MANDATORY SERVICE BULLETIN

DATE: January 30, 2003**Service Bulletin No. 475C**
(Supersedes Service Bulletin No. 475B)
Engineering Aspects are
FAA Approved**SUBJECT:** Crankshaft Gear Modification and Assembly Procedures**MODELS AFFECTED:** All Lycoming direct drive piston aircraft engines (including VO-360 and IVO-360; excepting O-320-H, O-360-E, LO-360-E, TO-360-E, LTO-360-E, and TIO-541 series engines).**TIME OF COMPLIANCE:** During overhaul, after a propeller strike, or whenever crankshaft gear removal is required.

Figure 1. Details for Repairing Pilot Diameter of Crankshaft

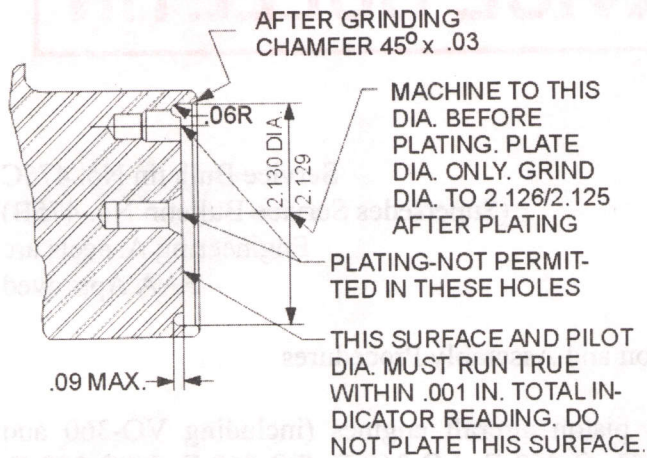
3. Check the pilot diameter of the counterbore on the end of the crankshaft for size and evidence of damage. This diameter should not exceed 2.1262 inches when measured at any location. If found to be oversize, the crankshaft may be repaired as described in the following steps. Do not attempt to reuse a crankshaft with an oversize pilot diameter.

- a. After removing the dowel, machine the pilot diameter in the end of the crankshaft to 2.129/2.130 inch as shown in the illustration. See Figure 1. Also, cut the .09 deep x .06R undercut as shown.

- b. Chrome or nickel plate the surface of the pilot diameter with a firmly bonded deposit that is free of pin holes, blisters and any other imperfections that could impair the function of the parts.

- c. After plating, stress relieve the shaft by baking at 390° to 410°F for 3 to 5 hours.
 - d. Grind the plated pilot diameter surface to 2.125/2.126 inch. Note that the diameter must run true with rear main journal within .001 inch total indicator reading.

- e. Chamfer edge of pilot diameter 45° x .03 as shown in Figure 1.
4. If the dowel has been removed, check the condition of the dowel hole in the crankshaft. If out of round or oversize, ream as required for installation of an oversize dowel. Available oversize dowels and the corresponding size for reamed holes are shown in Table 1.
5. Install a new dowel in the crankshaft as shown in Figures 2 and 3. Insure that the correct dowel is installed.

Figure 2. Section Thru End of Crankshaft Showing Driven Height of STD-1065 Dowel

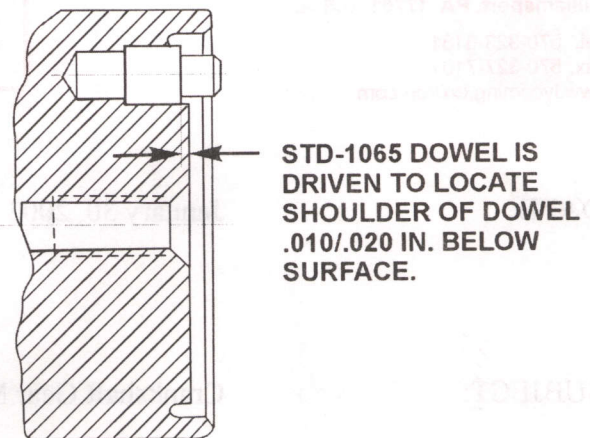
2. Check the condition of the dowel in the end of the crankshaft. It should be perfectly smooth with no indication of nicks or deformation. If it is out of round, it should be removed and replaced with a new one. Replacement instructions are in paragraph 4. If dowel condition is acceptable, insure that it is installed as shown in Figure 2 or 3.

Figure 5. Details for Rework of Crankshaft Gears to Current Configuration

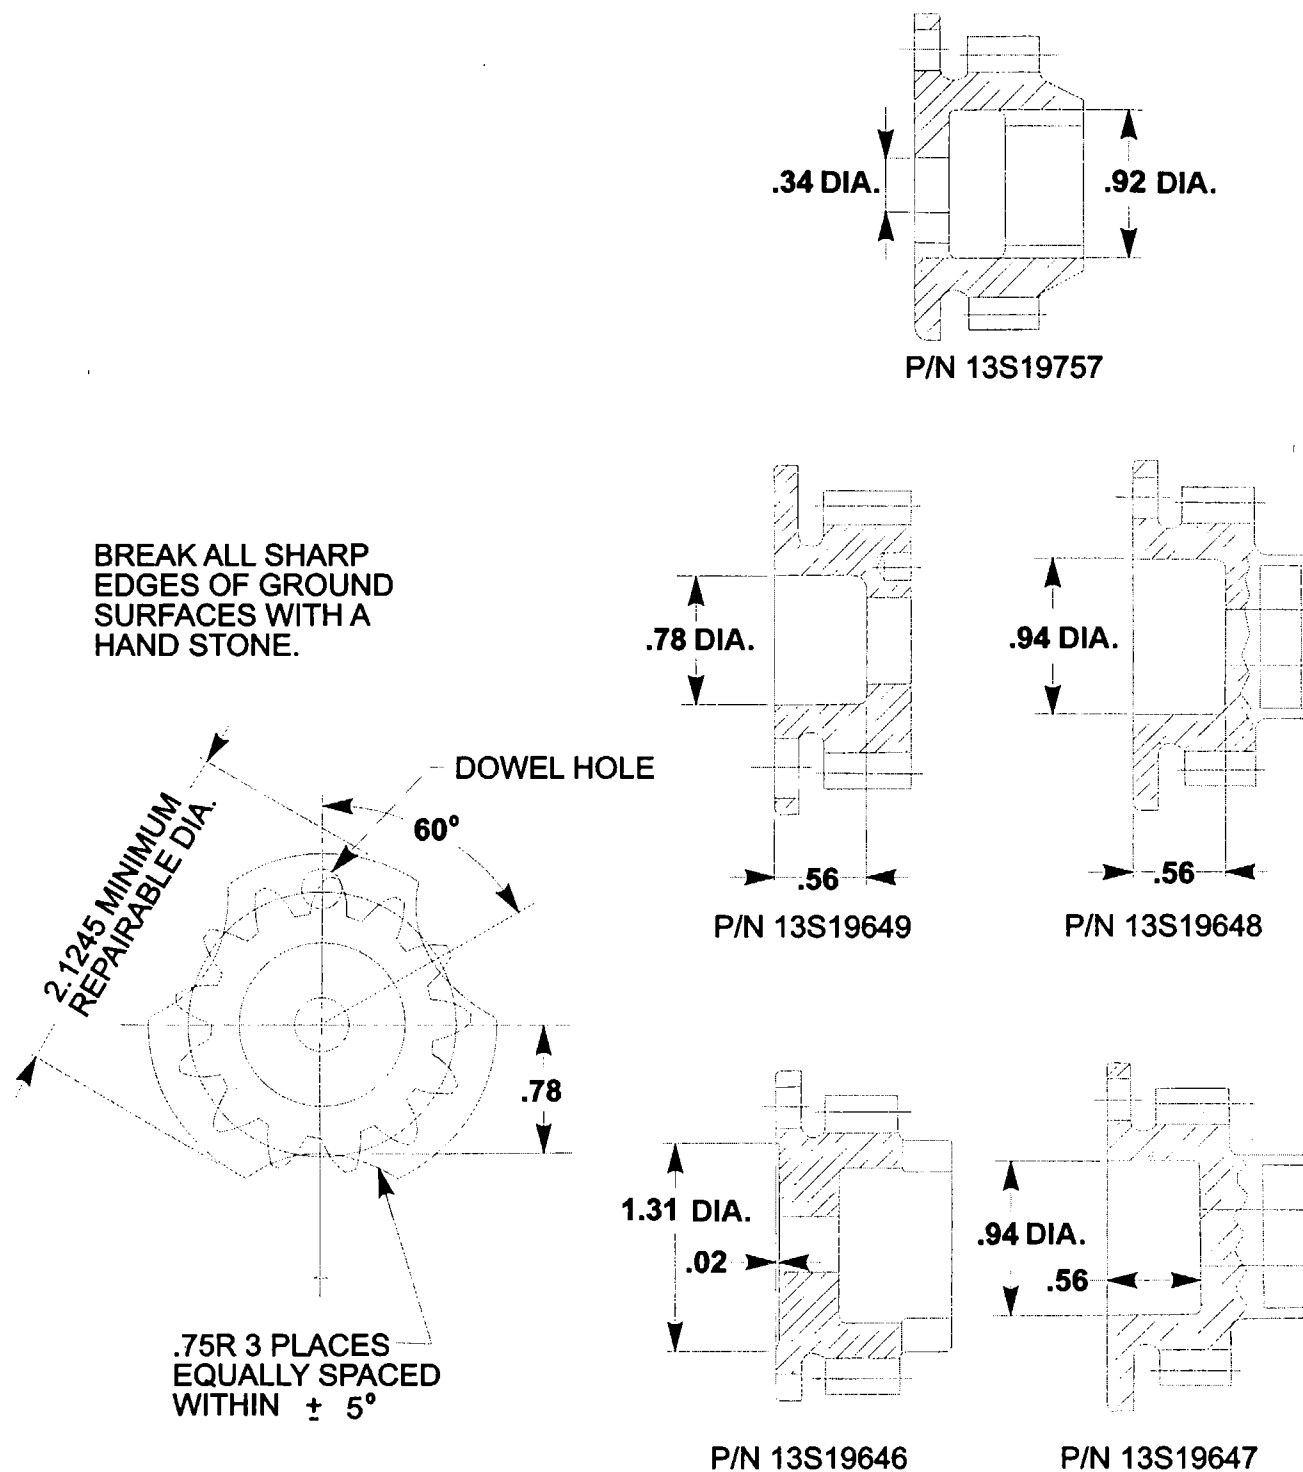
CRANKSHAFT GEARS FOR APPLICABLE ENGINES ARE NOW MANUFACTURED WITH THREE 3/4 INCH RADIUS SCALLOPS CUT INTO THE O.D. OF THE PILOT FLANGE AND A COUNTERBORE ON THE BACK SIDE OF THE GEAR. THESE ENLARGED SCALLOPS HAVE BEEN ADDED TO ALLOW INSPECTION OF THE GEAR AND CRANKSHAFT ASSEMBLY. SERVICEABLE GEARS MUST BE MODIFIED AS SHOWN IN FIGURE 5. PRIOR TO BEING REASSEMBLED ON THE CRANKSHAFT, OR A NEW GEAR THAT HAS BEEN MANUFACTURED TO THIS CONFIGURATION MUST BE INSTALLED. BEFORE MODIFYING THE GEAR, MEASURE THE DIAMETER OF THE PILOT FLANGE. IF IT IS LESS THAN 2.1245 INCH, IT SHOULD NOT BE RESUED. THE ORIGINAL 2.1250/2.1255 DIMENSION OF THE CRANKSHAFT GEAR MUST BE RESTORED WITH A FLASH COPPER PLATE OF UP TO .0005 INCH MAX.

NOTE: Revision "C" revises Table 2 and Figure 5.

Figure 6. Rear End View of Crankshaft Showing Associated Parts

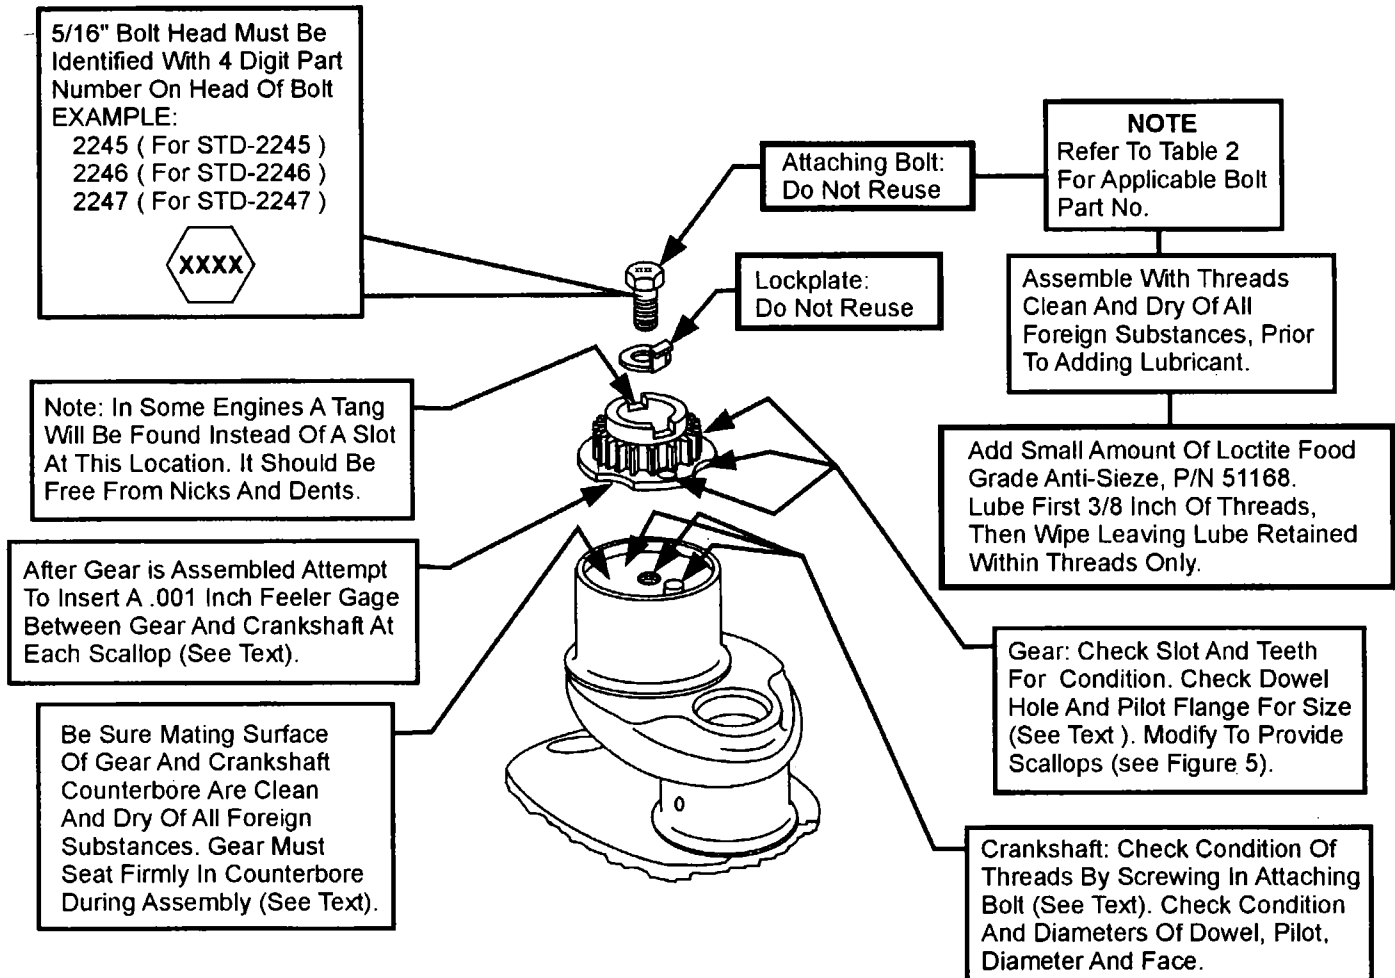
6. Assemble the gear to the crankshaft **using both a new lockplate and bolt**. Refer to Figure 6. The correct bolt, lockplate and dowel for each gear are shown in Table 2. Tighten the bolt to 125 in.-lbs. torque, then with a hammer and brass drift, tap lightly around the pilot flange of the gear and listen for sharp solid sounds from the hammer blows that would indicate that the gear is seated against the crankshaft. As a check on the seating against the crankshaft, attempt to insert a pointed .001 inch thick feeler gage or shim stock between the gear and crankshaft at each of the three scallops. The .001 feeler gage, or any smaller feeler gage, must **NOT** fit between the two surfaces at any location. (.001 feeler gage is used as an indicator, however, there must be no clearance between crankshaft and gear.) Retighten the gear attaching bolt to the proper torque. Tighten the 5/16 inch bolt to 204 in.-lbs. torque or the 1/2 inch bolt to 660 in.-lbs. torque. Measure the clearance between the O.D. of the gear flange and the pilot I.D. of the crankshaft. There should not be more than .0005 inch clearance at any point.

Figure 7. Minimum Dimension of Crankshaft

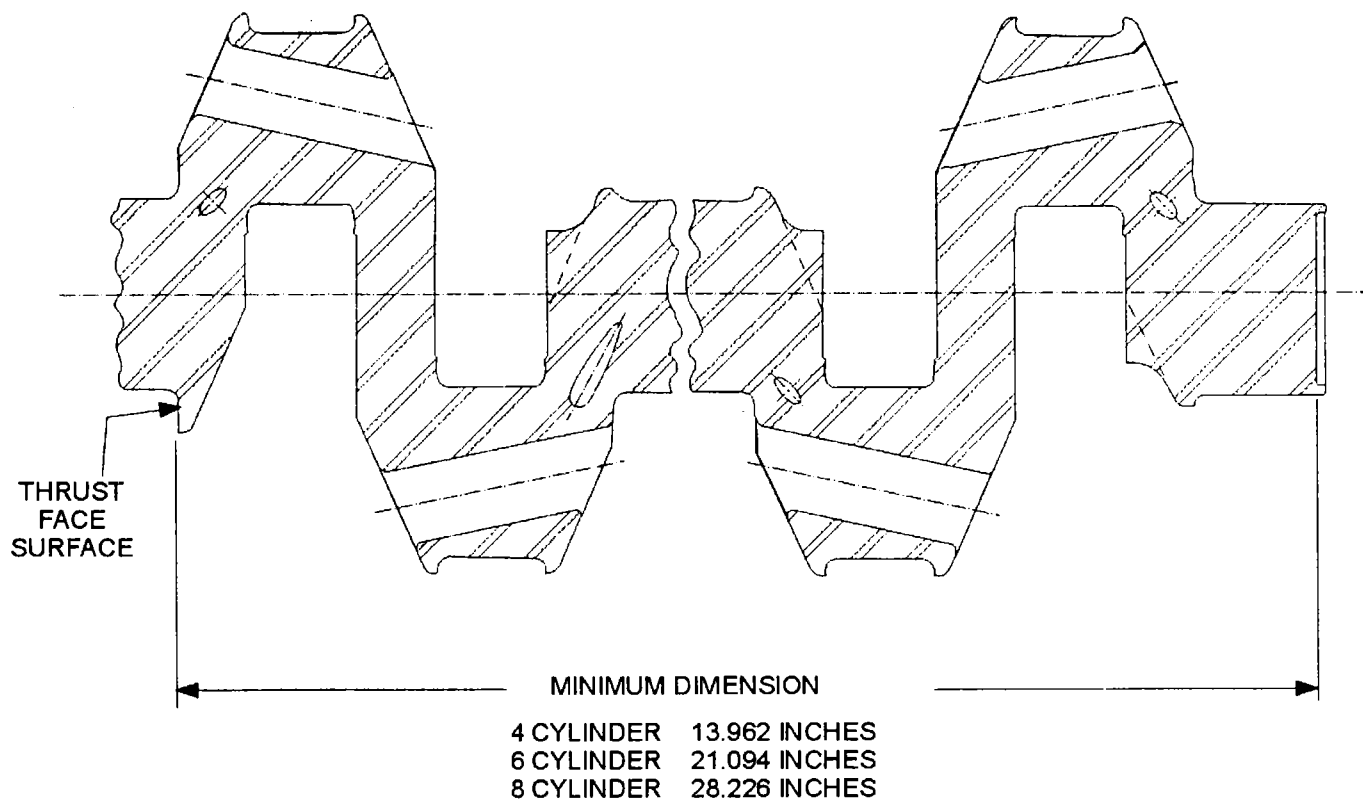
THE CRANKSHAFT COUNTERBORED GEAR MOUNTING FACE SHOULD BE CHECKED FOR DAMAGE. IF THE SURFACE REQUIRES REPAIR OTHER THAN SPECIFIED IN "CAUTION" ON PAGE 1, THE CRANKSHAFT SHOULD FIRST BE MEASURED AS SHOWN IN FIGURE 7. IF THE CRANKSHAFT MEASURES MORE THAN THE MINIMUM DIMENSION SHOWN IN FIGURE 7, THE SURFACE MAY BE REWORKED DOWN TO THE DIMENSIONS SHOWN. (DO NOT PLATE THIS SURFACE.) THE SURFACE MUST BE TRUE WITHIN .001 IN. TOTAL INDICATOR READING TO REAR MAIN BEARING AND THE SURFACE FINISH MUST BE HELD TO 45 TO 90 MICROINCHES.

INSURE MINIMUM DIMENSION IS MEASURED BETWEEN THRUST FACE SURFACE AND PILOT.
